**MONTGOMERY COUNTY HISTORIC PRESERVATION COMMISSION**  
**STAFF REPORT**

<b>Address:</b>	5625 Lambeth Road, Bethesda	<b>Meeting Date:</b>	6/9/2021
<b>Resource:</b>	Contributing Resource (Greenwich Forest Historic District)	<b>Report Date:</b>	6/2/2021
<b>Applicant:</b>	Yalda Ghamarian	<b>Public Notice:</b>	5/26/2021
		<b>Tax Credit:</b>	N/A
<b>Review:</b>	HAWP	<b>Staff:</b>	Michael Kyne
<b>Case Number:</b>	951716		
<b>PROPOSAL:</b>	Rear addition, window replacement, and other alterations

PROPOSED WINDOW & EXIST.SHUTTER

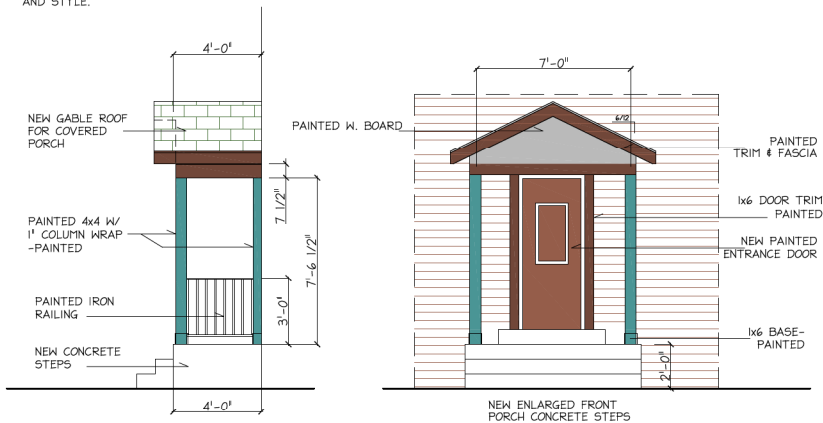
1. **The proposed replacement windows on the south (front), east (right), and west (left) elevations will be 6-over-6 wood (not clad) SDL windows with permanently-affixed 7/8" interior and exterior muntins and internal spacer bars. Final specifications must be submitted to staff for review and approval prior to submission of the final permit drawings.**

Regarding the proposed window replacement, the *Guidelines* state “[d]oor and window replacements are acceptable, as long as the replacements are compatible with the architectural style of the house. Replacement windows with true or simulated divided lights are acceptable, but removable ('snap-in') muntins are not permitted on front-facing windows of contributing houses.” Because the windows to be replaced on the front and side elevations are visible from the public right-of-way, the *Guidelines* require review with strict scrutiny. Strict scrutiny is defined as “...the highest level of review. It adds consideration of the integrity and preservation of significant architectural or landscape features and details to the requirements of the limited and moderate scrutiny levels. Changes may be permitted if, after careful review, they do not significantly compromise the original features of the structure or landscape.”

Staff finds that the original windows are a significant character-defining feature of the subject property, and their character (style, approximate dimensions, and material) should be preserved. Principle A2 also stresses high-quality building materials and a high level of craftsmanship as an essential element to the fabric of the Greenwich Forest Historic District. Accordingly, staff recommends a condition of approval, stipulating that the proposed replacement windows on the south (front), east (right), and west (left) elevations will be 6-over-6 and 4-over-4 wood (not clad) SDL windows with permanently-affixed 7/8” interior and exterior muntins and internal spacer bars. Final specifications must be submitted to staff for review and approval prior to submission of the final permit drawings.

NEW WINDOWS ANDERSON 100 #  
SERIES, W/ MULLIONS, SAME SIZE  
AND STYLE.

PROPOSED FRONT PORCH

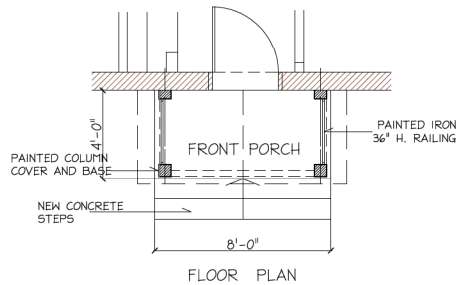
The existing front porch with shed roof is proposed to be replaced with a new front porch with gable front roof. The applicant has stated that the footprint of the porch will not change (the proposed new porch will be 4' deep x 8' wide, but the existing dimensions have not been provided). The proposed new front porch materials include 36" high iron railings on the east (right) and west (left) sides, concrete steps and landing, 4x4 wood wrapped columns, slate roofing to match the existing house, and wood fascia and trim.

Staff also finds that the *Guidelines* support the proposed front porch replacement. Regarding porches, the *Guidelines* state that “[t]he addition of front porches is permitted if they are compatible with the architectural style of the house.” Staff finds that the same consideration should be given to front porch alterations/replacement, as the *Guidelines* allow some latitude regarding changes to a building’s façade. Specifically, the guidelines regarding changes to architectural style state “[c]hanges to the facades of contributing houses and additions thereto are permitted if the new front elevation: (1) is consistent with a style of another contributing house; and (2) is suitable to and does not significantly alter the original outline, shape and scale of the original structure.”
